Access Compliance Report

Public Rights-of-Way

(Curb Ramps)

| Intersection ID: 10025869 | Main Street: ELEVATION_POINT_DR | Cross Street: N/A | Location: NW |

| ADA ID: C53ACA698C68 | Ramp Type: Perp | Initial Pass/Fail: Pass | Overall Compliance: No |

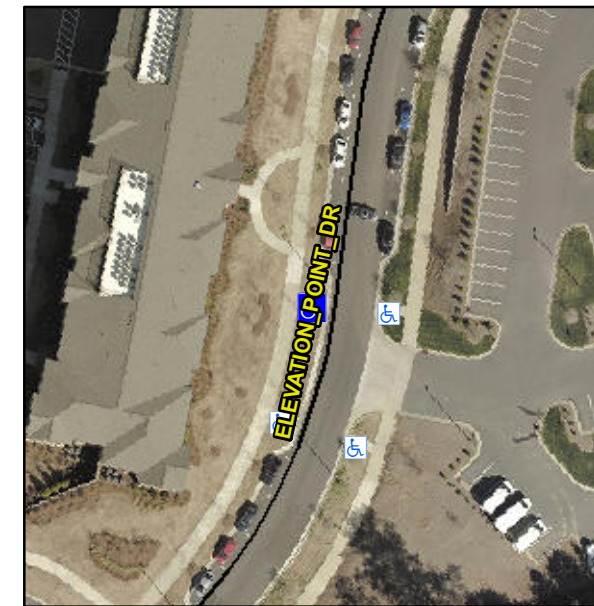
Not Found, R304.5.3, R304.5.4

| Compliance | Description | Data | Compliance | Description | Data |
|------------|-----------------------|----------------------|------------|-----------------------------|------|
| Yes | Ramp Width (in) | 60.0 | No | Ramp XSlope (%) | 3.2 |
| No | Landing X Slope (%) | 3.3 | Yes | DWS Full Width? | Yes |
| Yes | Gutter Ponding? | No | No | Gutter Slope (%) | 5.4 |

**Remove & Replace Entire Ramp.
Remove & Replace Gutter.**
